Addressing the changes in Table 33-1 for supporting Type 3 and 4 PSEs Inrush.

9 **33.2.7.5 Output current in POWER\_UP mode**

Figure 33-13— $I_{Inrush-2P}$  current and timing limits, per pairset in POWER\_UP

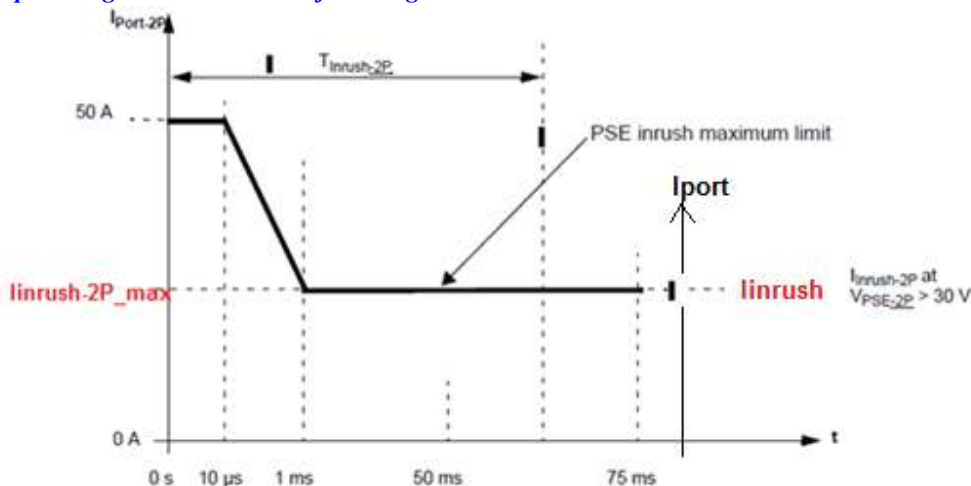
28  
29 Addressing the effect of E2EP2PRunb on `linrush-2P` and linking `linrush` requirements for all PSE types to Table 33-11  
30 Figure 33-13 was modified to address the effect of end to end pair to pair resistance unbalance on the maximum limit of `linrush-2P` which by simulation found to be 0.556A adding margin → 0.6Amax. This value will be updated in Figure 33-13 as well to cover requirements below 1msec.

Replace Figure 33-13 with the following:

The PSE inrush maximum limit,  $I_{PSEIT-2P}$ , is defined by the following segments:

$$I_{PSEIT-2P}(t) = \left. \begin{array}{ll} 50.0 & \text{for } 0 < t < 10.0 \times 10^{-6} \\ \text{TBD=function of} & \text{for } 10.0 \times 10^{-6} \leq t < 0.001 \\ \text{(t, linrush-2P\_max)} & \\ \text{linrush-2P\_max} & 0.001 \leq t < 0.075 \end{array} \right\} \text{A} \quad (33-5)$$

Editor Note: To update the TBD in equation 33-5. Add Equation 33-5a after equation 33-5 to describe the template of figure 33-13 for linrush.
